SUNDRY NOTICES AND REPORTS ON WELLS
 (DO NOT USE THIS FORM FOR PROPOSALS TO DRILL OR TO DEEPEN OR PLUG BACK TO A DIFFERENT RESERVOIR. USE "APPLICATION FOR PERMIT" (FORM C-101) FOR SUCH PROPOSALS.)

2. Name of Operator
 Yates Petroleum Corporation

7. Lease Name or Unit Agreement Name
 Mitchell IN

Yates Petroleum Corporation plans to plug and abandon this well as follows:

Wellbore schematics attached

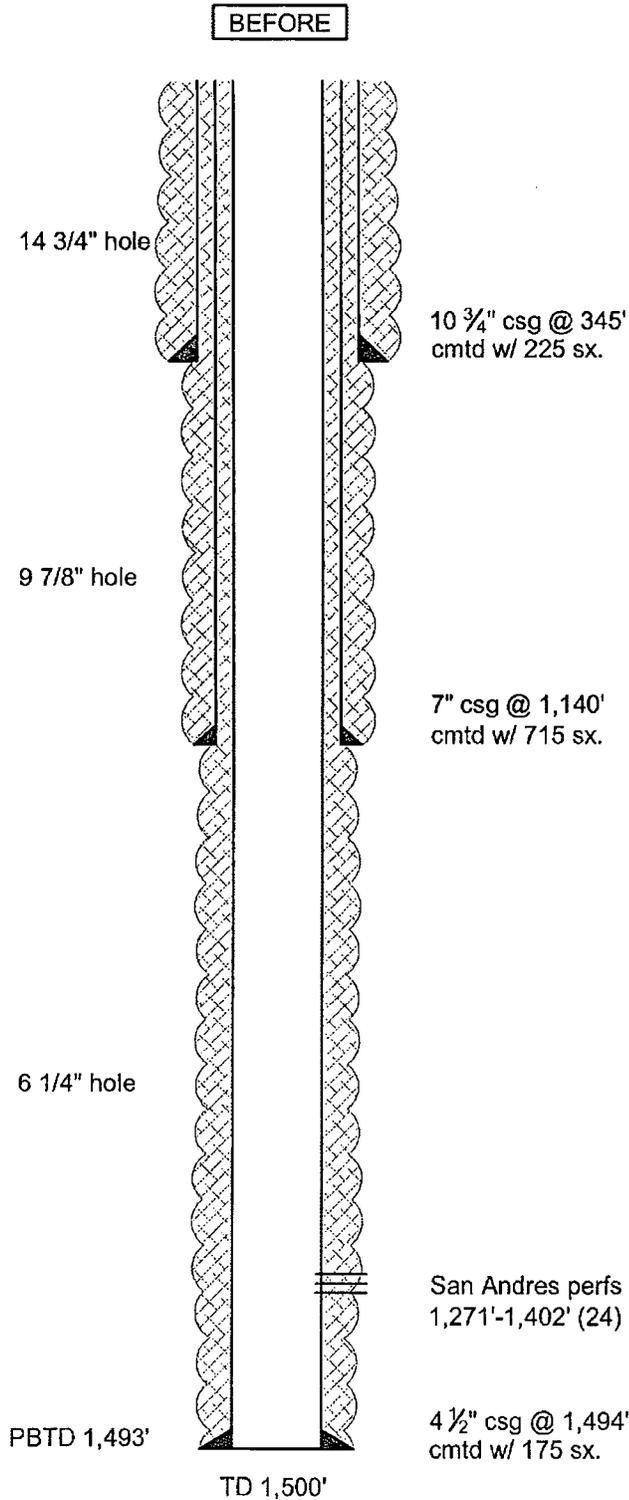
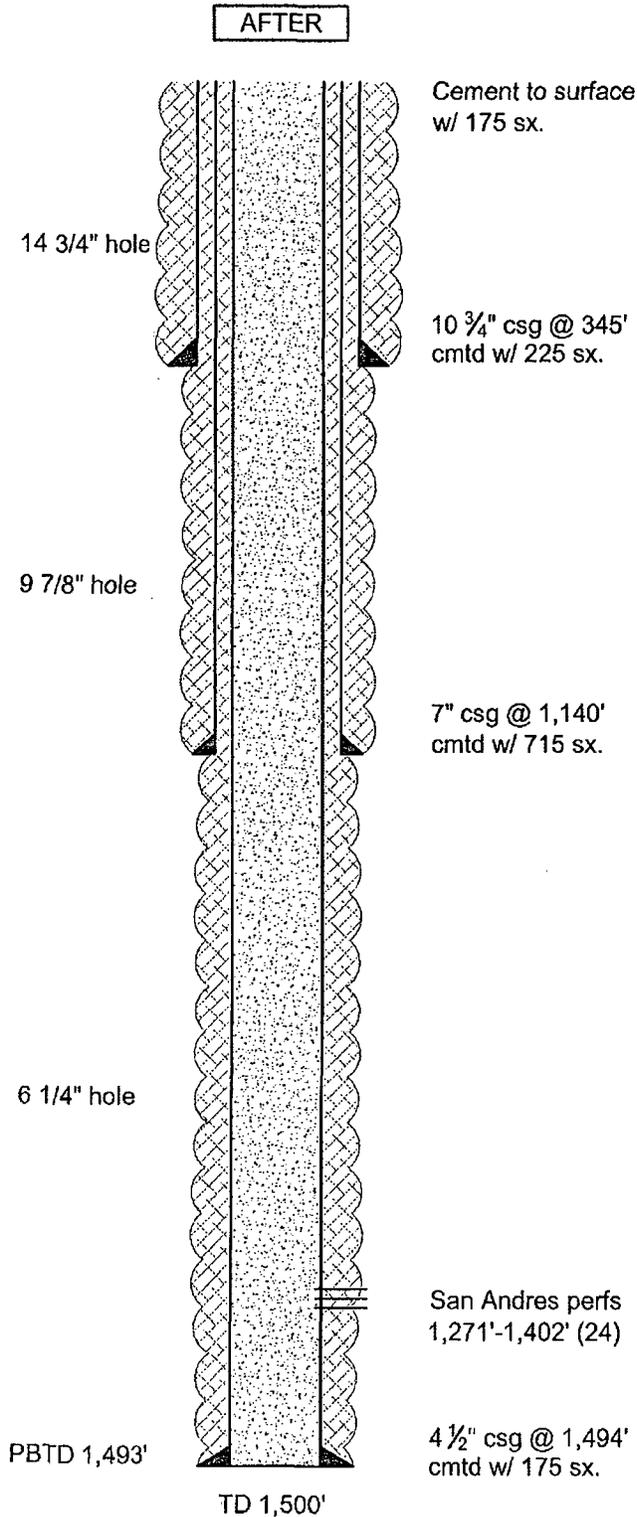
- MIRU any safety equipment as needed. NU BOP. TOH with production equipment.
- RIH with bit and scraper to just below perfs at 1430' and circulate class "C" cement to 500' with 115 sx. NOTE: If fill is tagged and you are unable to get below the perfs then TOH and TBIH with CIBP and set above perfs at 1230' before circulating cement to 500' (90 sx).
- Cut off wellhead and verify that there is cement behind all casing strings at surface. If so, cement to surface with 60 sx. If not then perforate and circulate cement to surface behind each casing string before cementing to surface inside production casing.
- Install dry hole marker and clean location.

7. Every attempt must be made to clean the well bore out to below the perms, before any plugs can be set, by whatever means possible.
8. **Cement Retainers may not be used.**

9. Squeeze pressures are not to exceed 500 PSI, unless approval is given by NMOCD.
10. Plugs may be combined after consulting with and getting approval from NMOCD.
11. Minimum WOC time for tag plugs will be 4 Hrs.
